Exhaust flapper valve

3.0, 4.3, 5.0, 5.7, 7.4, 8.2 Gas Sterndrive Engines

Date: 9-1999

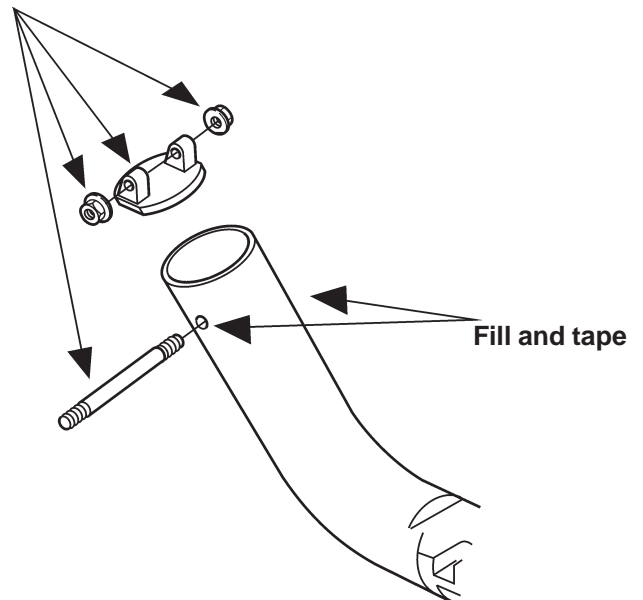
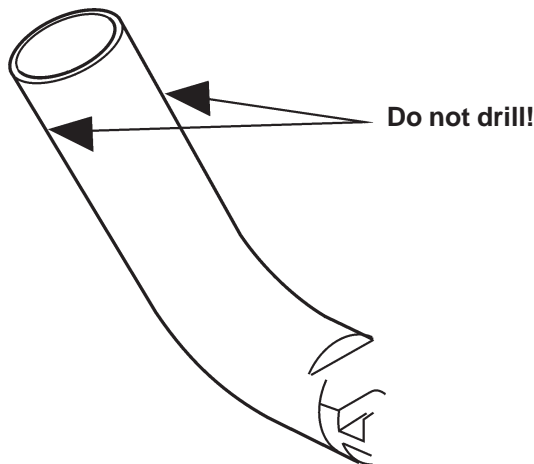
After extensive testing Volvo Penta has found that the exhaust flapper valve located in the exhaust pipe is not effective in preventing water ingestion. The valve has a short lifespan and has been known to disconnect from its pivot rod and clog the exhaust system. Therefore, Volvo Penta will no longer include an exhaust flapper valve on the engines listed above.

The exhaust flapper valve (3853864-1), pin (3852753-7), and bushings (3855517-3) will no longer be available through Volvo Penta Parts. New exhaust pipes from our parts system will be delivered without the exhaust flapper valve. Do not attempt to install an exhaust flapper valve in a new exhaust pipe.

Remove and discard

4. Fill the holes with silicone.
5. Cover the holes with masking tape.

1. Do not reinstall the valve.
2. Remove and discard the valve, pin, and bushing.
3. On the exhaust pipe, clean out any residue from the holes.

6. Reinstall the exhaust bellows. Make sure the bellows cover the masked holes.
